## DEVIATION REQUEST AND DECISION FORM

Project Name : Crossroads North

A deviation from the standards of or in Appendix F, Standard Drawings, **SD 2-3, Urban Non-Residential Collector** and **Table 2-7. Roadway Design Standards for Urban Collectors and Locals**- of the Engineering Criteria Manual (ECM) is requested.

SCALE: NOT TO SCALE

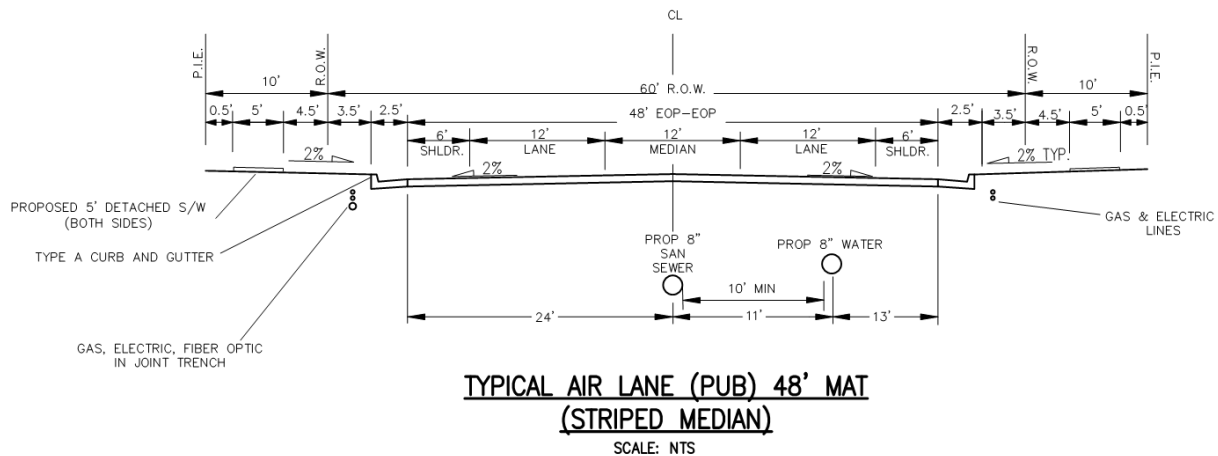
A deviation from the standard Urban Non-Residential Collector Roadway Cross Section for Air Lane is requested. The standard cross section includes two travel lanes (12'), a striped median (12'), and two shoulders (6') within a 48-foot wide pavement mat; two 2.5-foot curb and gutter at the end of the pavement mat, two eight (8) foot (typical) landscape/tree lawns, two five (5) foot detached sidewalks all within an 80-foot ROW.

The proposed public road cross section includes the following deviation(s) from standard ECM Standards for an urban residential collector section. Requesting;

- 60-foot ROW. Typical cross section is within an 80-foot Public ROW.
- 48-foot pavement width, where typical cross section has a 48' pavement width. No change.

- Two 12-foot travel lanes with two 6' shoulders, where typical cross section has two 12-foot travel lanes with two 6' shoulders. No Change
- Striped 12' median, whereas typical cross section has 12' striped median. No change.

- 5-foot detached sidewalk, where typical cross section has 5' detached sidewalks, No Change.
- Two 10' Public Improvement Easements, whereas typical cross section contains none.

- Two 8' landscape/tree lawns. Typical cross section has two 8' landscape/tree lawns.
- Typical cross section intersection spacing is 660' or 330' when intersecting local roadways. The layout of all of the commercial lots is not known at this time. Therefore, a deviation for the future applications will be necessary. Access spacing will also need to be considered. (Table 2-35)

- Temporary parking will be permitted on the future sports park development side. Typical cross section does not allow parking on either side.
- The sidewalk on the south side of Air Lane will be installed with the development of the land inside the City limits (City owned lots). The property south of Air Lane is planned to be developed into a recreational park and pedestrian access will be widely addressed. The City does not and cannot grant themselves a public easement.

This request has been determined to have met the criteria for approval. A deviation from **Chapter 2 Table 2-7, and Appendix F, SD 2-4** of the ECM is hereby granted based on the justification provided.
